Document type: Text for FPDAM ballot or comment

Title: ISO/IEC 10373-6:2001/FPDAM 8.2 - Identification cards - Test methods - Part 6: Proximity cards - Amendment 8: Additional PICC classes

ISO/IEC 10373-6:2001/PDAM 8.2

AMENDMENT 8
Additional PICC classes

Figure 1 — Calibration coils 1 and 2

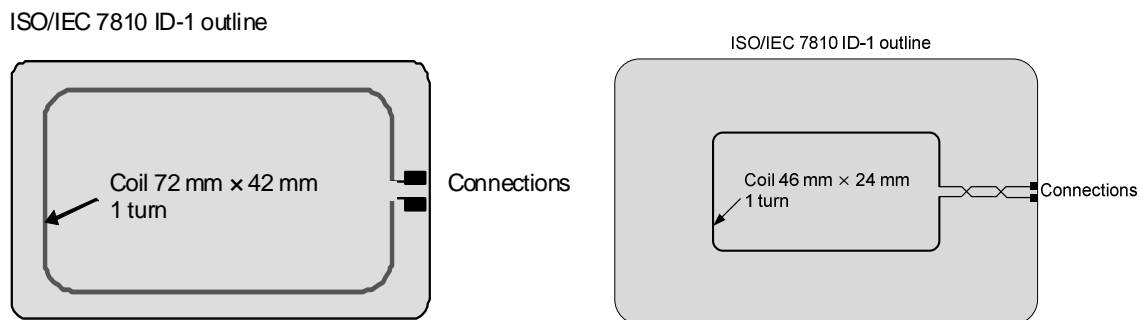
Replace subclause 5.2 by the following:

This clause defines the size, thickness and characteristics of the calibration coils 1 and 2.

The coil on the calibration coil card shall have one turn. Relative dimensional tolerance shall be $\pm 2\%$.

The outer size of the calibration coil 1 shall be 72 mm \times 42 mm with corner radius 5 mm.

The outer size of the calibration coil 2 shall be 47 mm \times 24 mm with corner radius 2 mm.

Figure 2 — Test set-up (principle)

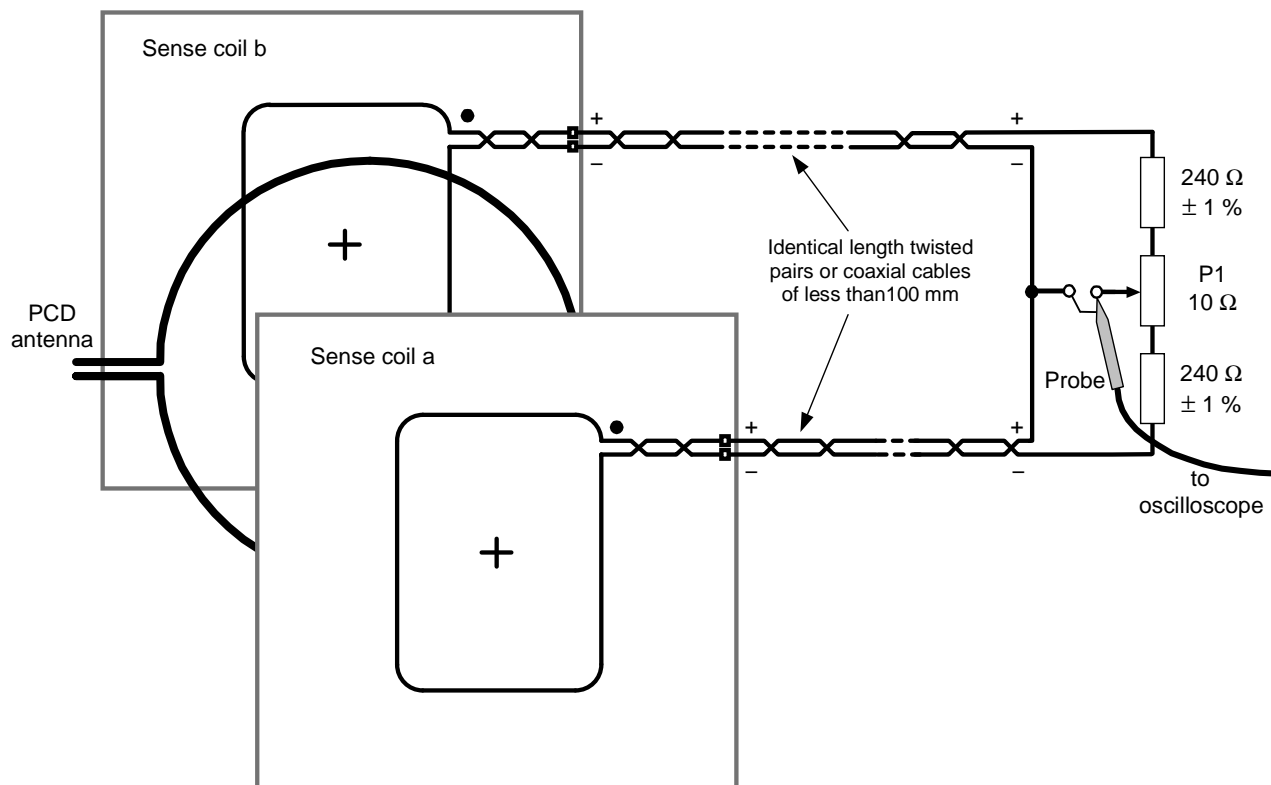
Replace subclause 5.3 by the following:

Each test PCD assembly shall consist of a circular test PCD antenna and two parallel sense coils: sense coil a and sense coil b. The test set-up is shown in Figure 2. The sense coils shall be connected such that the signal from one coil is in opposite phase to the other. The 10 Ω potentiometer P1 serves to fine adjust the balance point when the sense coils are not loaded by a PICC or any magnetically coupled circuit. The capacitive load of the probe including its parasitic capacitance shall be less than 14 pF.

Figure 3 — Test PCD assembly

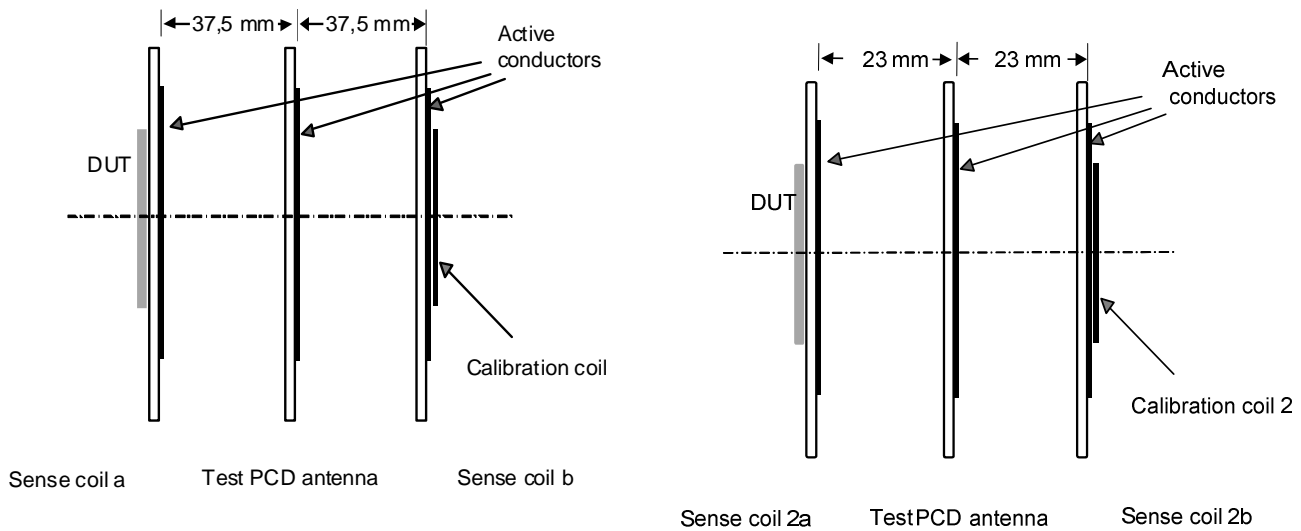
The sense coils 1 and test PCD antenna 1 shall be assembled parallel and with the sense and antenna coils coaxial and such that the distance between the active conductors is 37,5 mm as shown in Figure 3.

The sense coils 2 and test PCD antenna 2 shall be assembled parallel and with the sense and antenna coils coaxial and such that the distance between the active conductors is 23 mm as shown in Figure 3.

The dimensional tolerance shall be better than $\pm 0,5$ mm. The distance between the coil in the DUT and the calibration coil shall be equal with respect to the coil of the test PCD antenna.

Figure A.7 — Test PCD antenna 2 layout including impedance matching network (view from front)

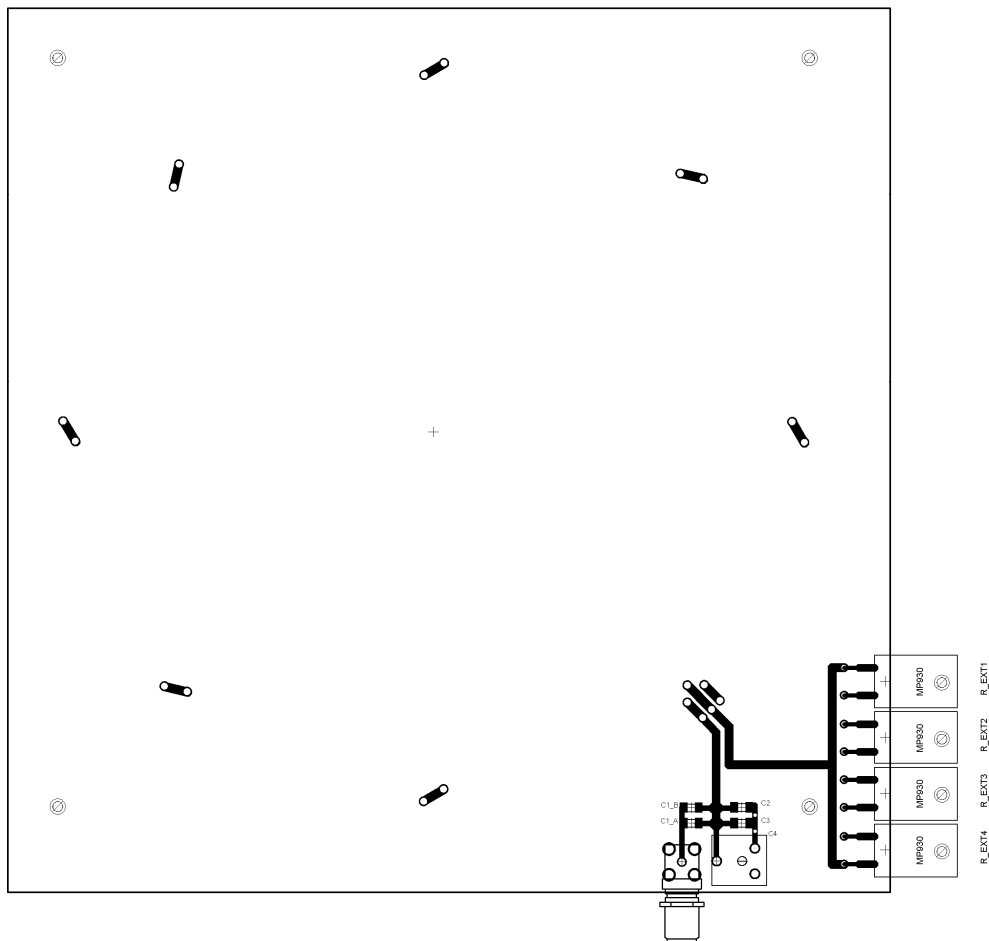
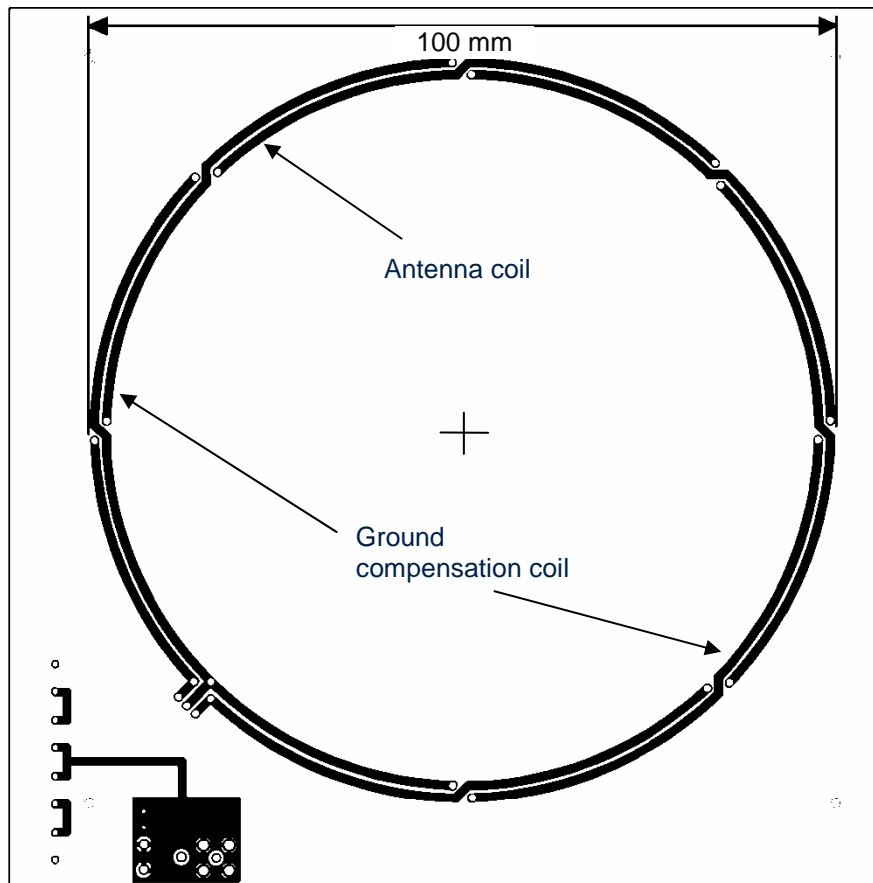
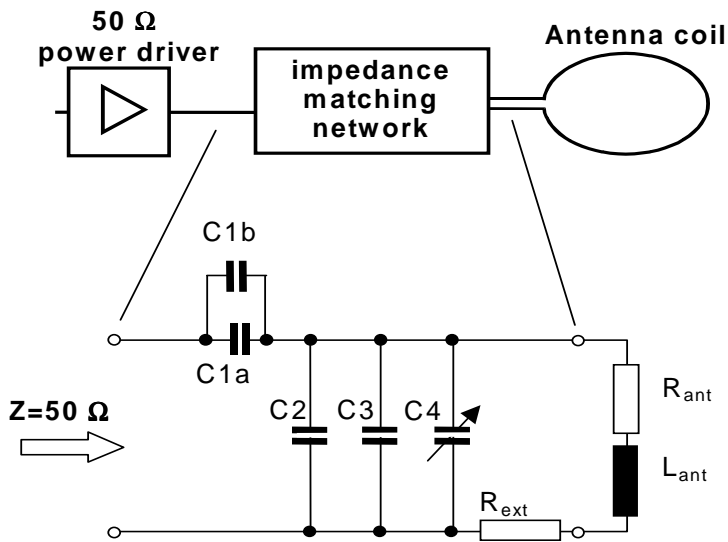
Add a new subclause at the end of annex A:

Figures A.7 and A.8 illustrate the Test PCD antenna 2 layout.

The antenna coil track width is 1,8 mm (except for through-plated holes).

Starting from the impedance matching network there are crossovers every 45 °.

Printed circuit board (PCB): FR4 material, thickness 1,6 mm, double sided with 35 µm copper.

Figure C.2 — Layout for sense coils 2 (a and b)

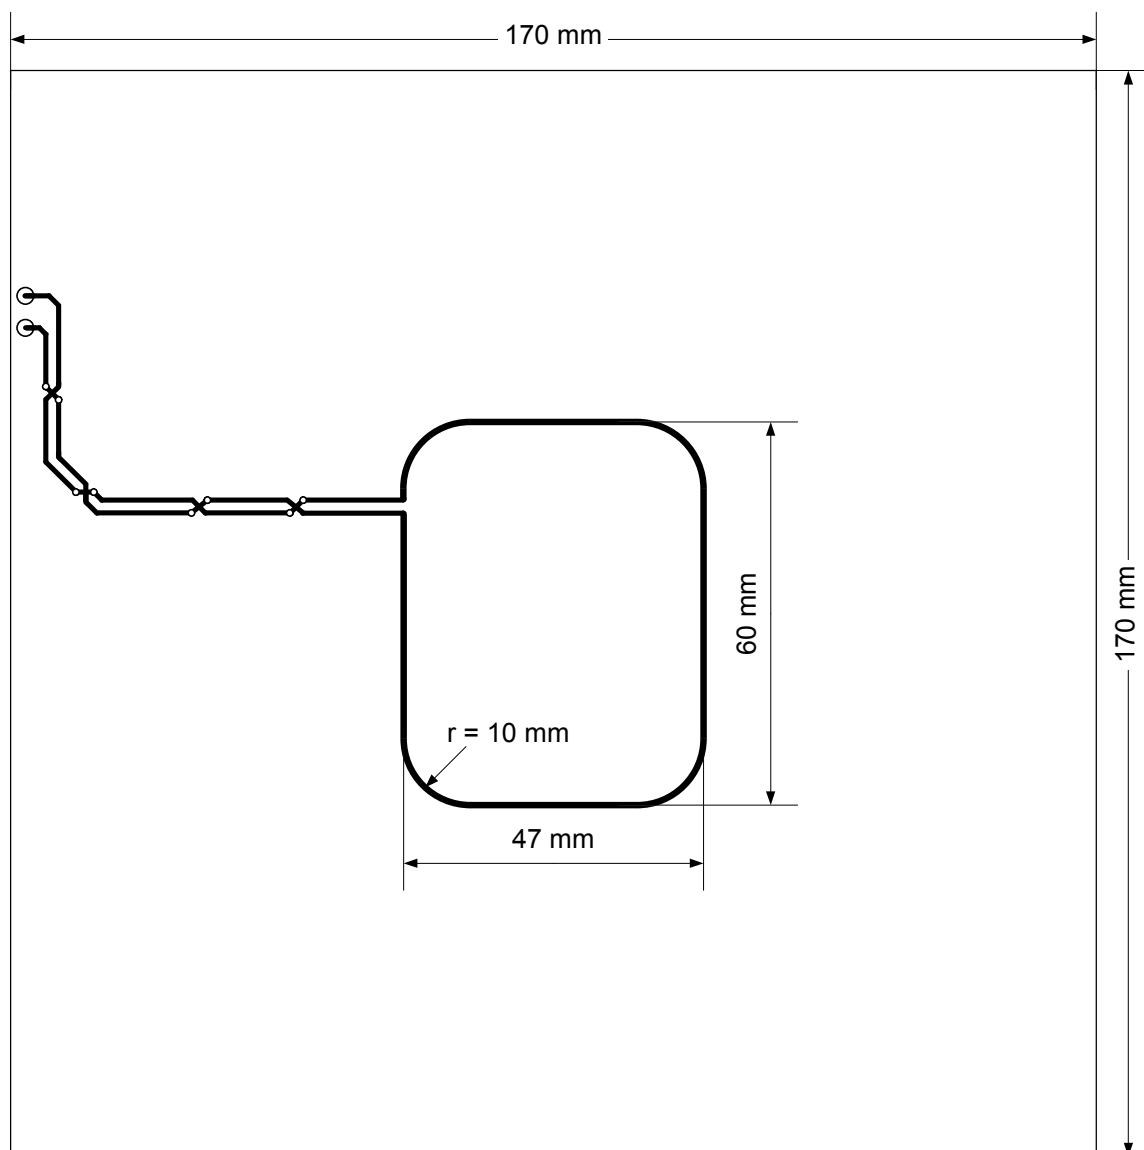
Add following sub clause before C.2 and renumber figures in Annex C:

The sense coil track width is 0,5 mm with relative tolerance ± 20 % (except for through-plated holes). Size of the coils refers to the outer dimensions.

Figure D.2 — Pick up coil and Main coil layouts

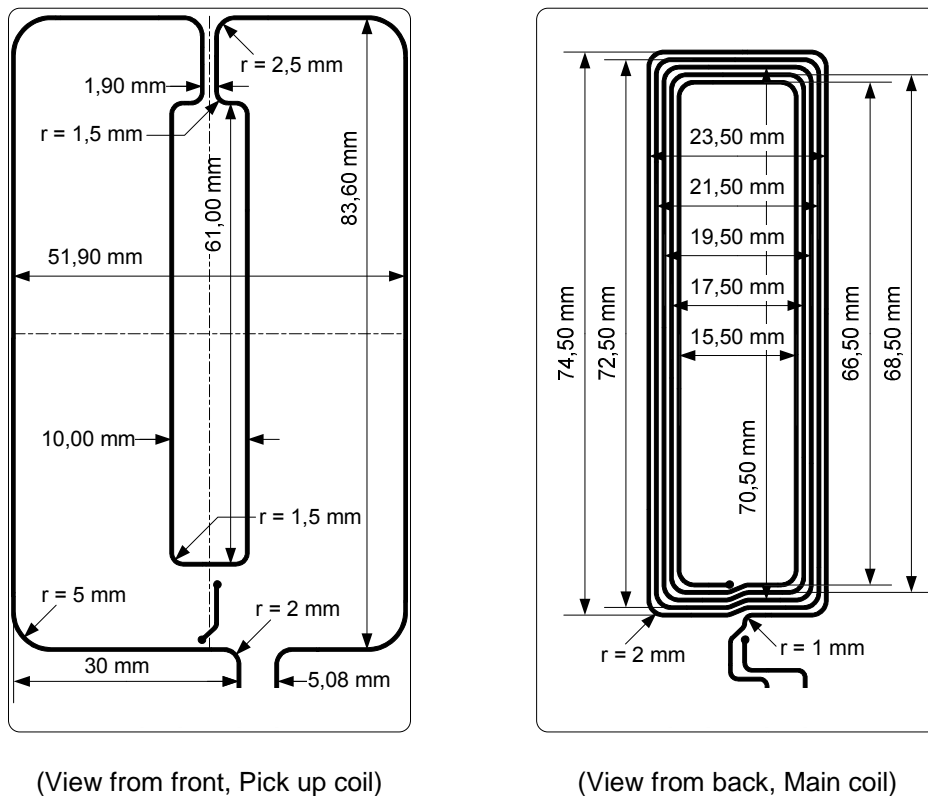
Add following sub clauses at the end of D.1:

Figure D.2 specifies the Reference PICC 2 Pick up coil and Main coil layouts.

Main coil dimensions: 75 mm x 24 mm (outer dimensions).

The two coils track width and spacing shall be 0,5 mm with a relative tolerance of $\pm 20 \%$.

Figure D.3 — Antenna layout

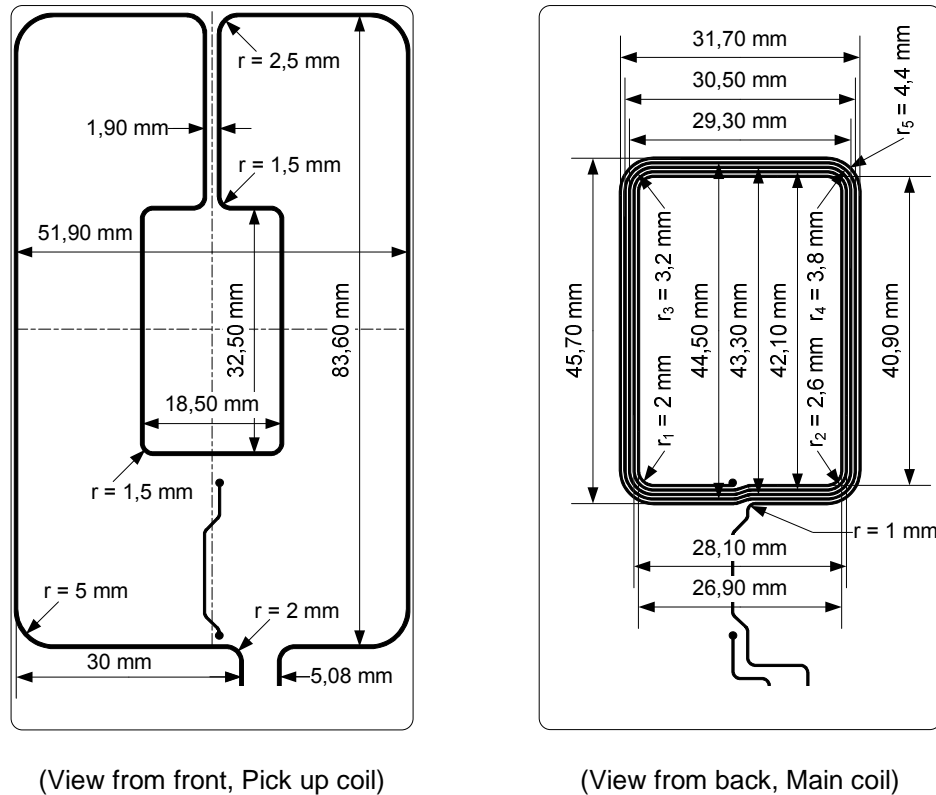
Figure D.3 specifies the Reference PICC 3 Pick up coil and Main coil layouts.

Main coil dimensions: 46 mm x 32 mm (outer dimensions).

The Main coil track width and spacing shall be 0,3 mm with a relative tolerance of $\pm 20 \%$.

Figure D.4 — Antenna layout

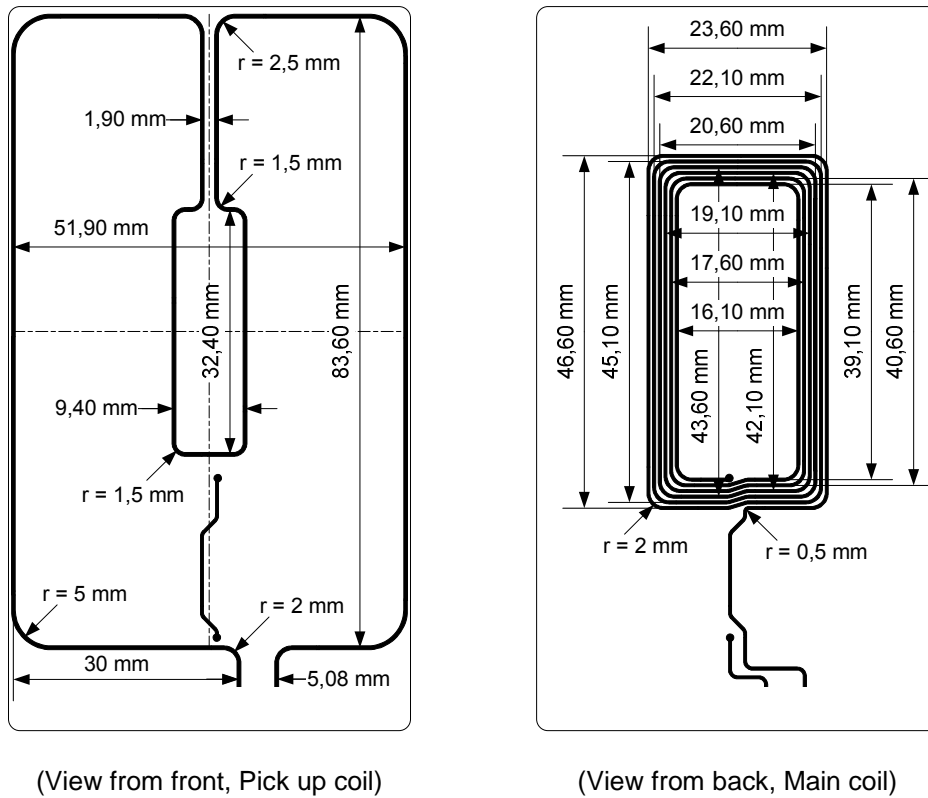
Figure D.4 specifies the Reference PICC 4 Pick up coil and Main coil layouts.

Main coil dimensions: 47 mm x 24 mm (outer dimensions).

The Main coil track width shall be 0,4 mm and the spacing shall be 0,35 mm with a relative tolerance of $\pm 20\%$.

Figure D.5 — Antenna layout

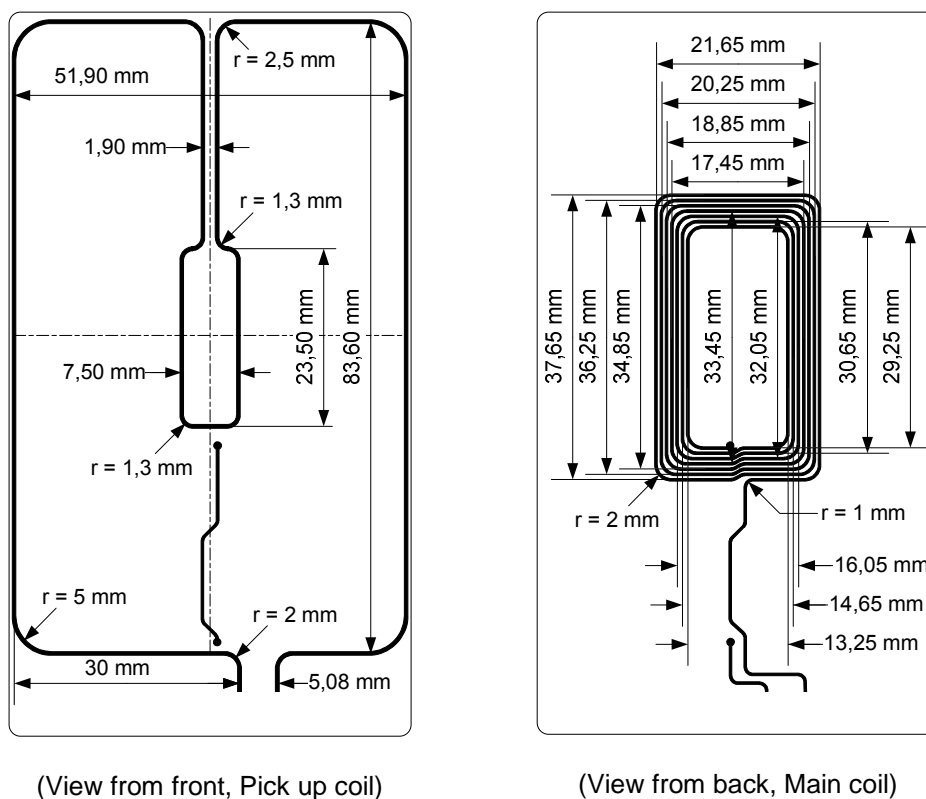
Figure D.5 specifies the Reference PICC 5 Pick up coil and Main coil layouts.

Main coil dimensions: 38 mm x 22 mm (outer dimensions).

The Main coil track width and spacing shall be 0,35 mm with a relative tolerance of $\pm 20\%$.

Figure D.6 — Antenna layout

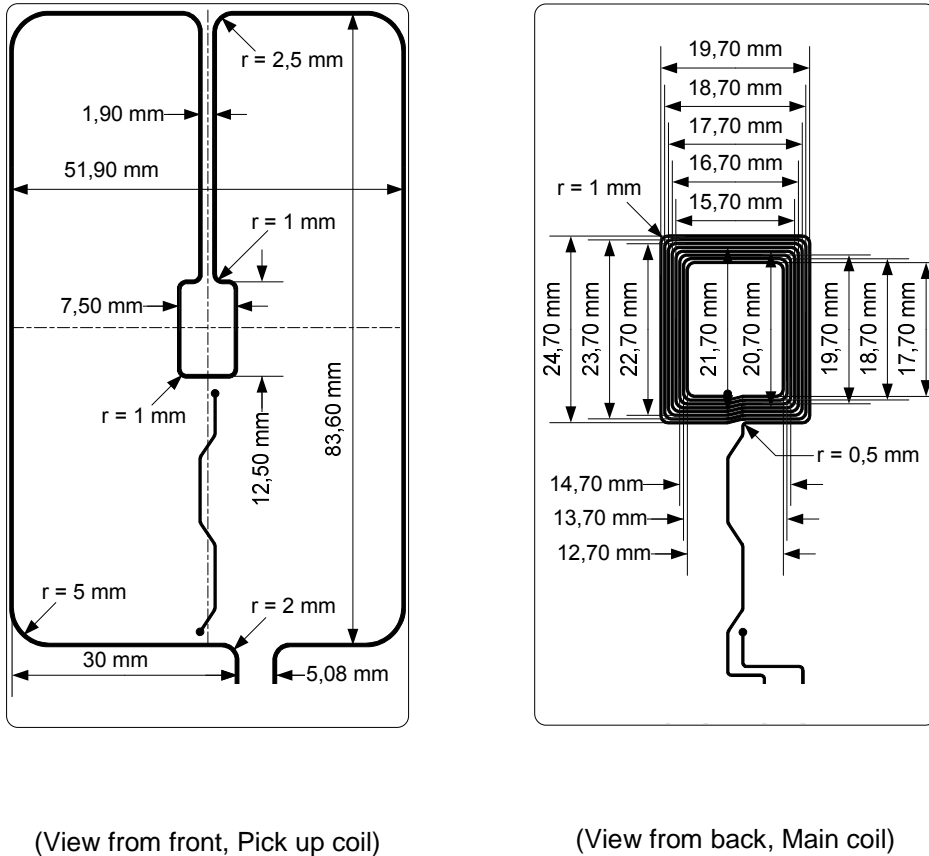
Figure D.6 specifies the Reference PICC 6 Pick up coil and Main coil layouts.

Main coil dimensions: 25 mm x 20 mm (outer dimensions).

The Main coil track width shall be 0,3 mm and the spacing shall be 0,2 mm with a relative tolerance of $\pm 20 \%$.
